Proposal: Proposed redevelopment of the at-grade Hughes Street car park, including the construction of a 2-storey open deck carpark comprising 219 car spaces (including 7 accessible car spaces and 12 service vehicle spaces) and the upgrade and reconfiguration of the existing multi-deck Dutton Lane carpark, with associated signage and wayfinding, subdivision, drainage works and landscaping at No. 34-40 Hughes Street, Cabramatta.

File No: DA 48.1/2019

Author: Hayley Tasdarian, Senior Development Planner
Fairfield City Council

Figure 6 – Pedestrian Connectivity

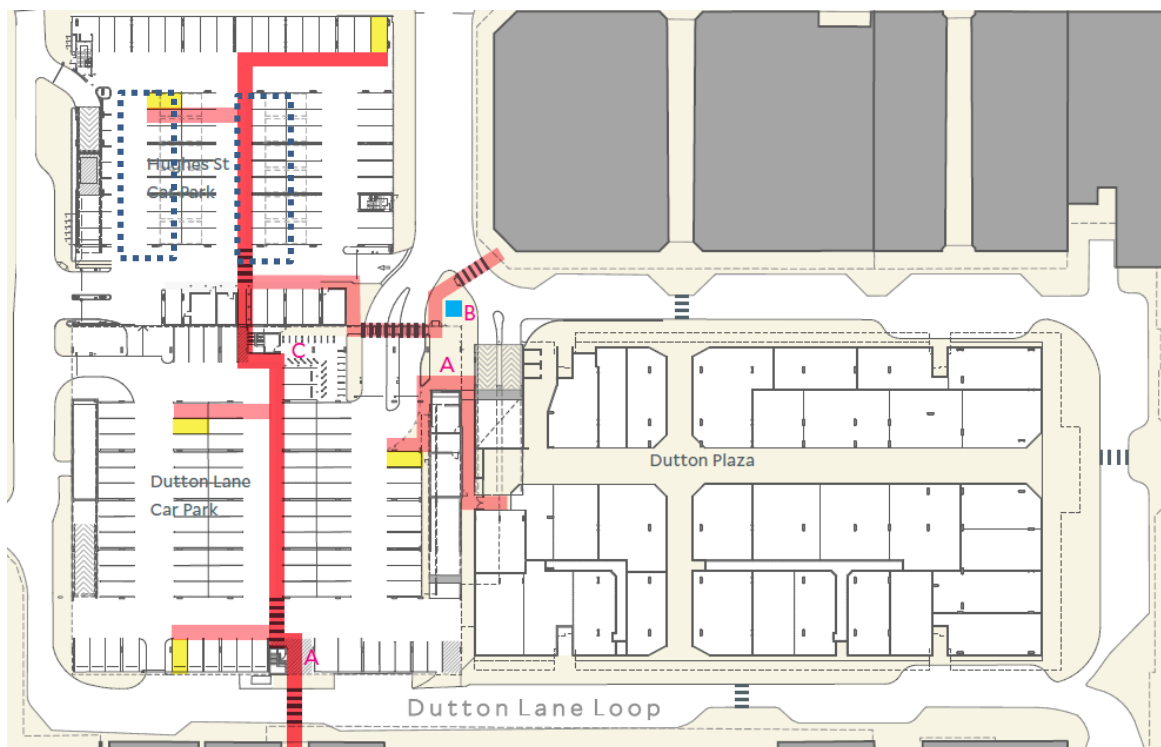
Initial assessment of the submitted plans raised concern in relation to pedestrian connectivity and safety, particularly at the vehicular entries and pedestrian links between the proposed and existing multi-deck car park. Concern was also raised for the efficient and safe movement of delivered goods from the proposed ground floor loading bays through the existing Dutton Lane car park and to the surrounding commercial premises.

In response, the applicant submitted diagrams demonstrating pedestrian access throughout the site and different travel paths for each of the car park users, including the movement of delivered goods through the site as shown in Figure 6 and Attachment F of this report.

Figure 3: Proposed Lift Core in context of surrounding development (outlined in red)

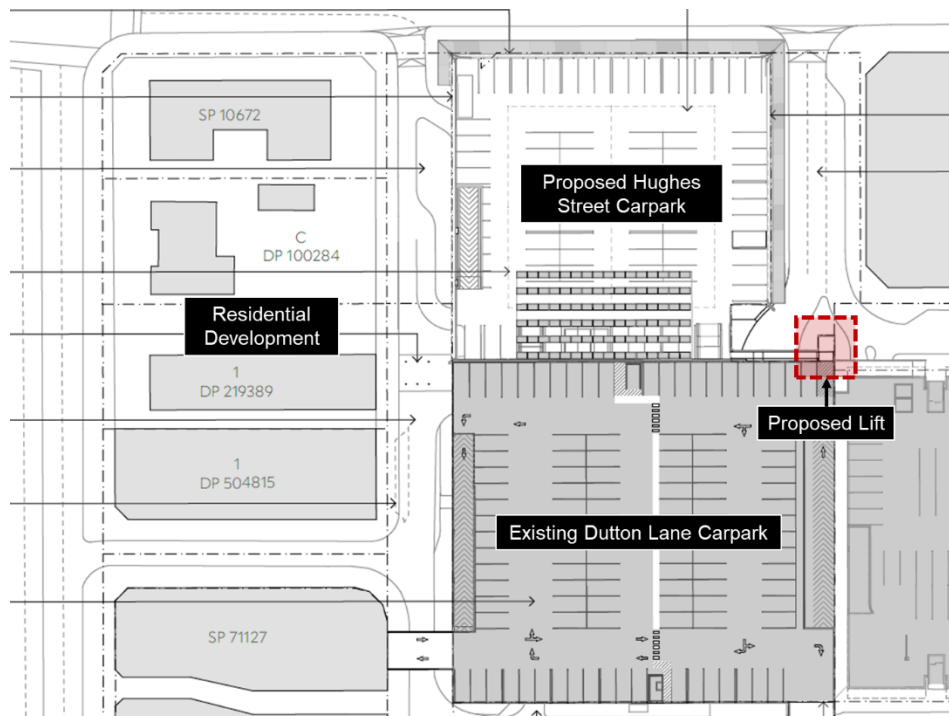
The lift core exceeds the height limit by 37.3%, however, it is screened with a coloured aluminium post screen and a digital signage panel. The lift core is proposed on the corner of the proposed carpark structure and existing Dutton Lane Carpark. The proposed lift is essential for the operational requirements of the car park.

The lift core occupies a small floor space and is located approximately 65 metres east of the residential development on the western boundary of the site (Figure 3). The visibility of the lift core structure from the residential development is limited due to the distance of the lift core from the site boundary and its architectural treatment.
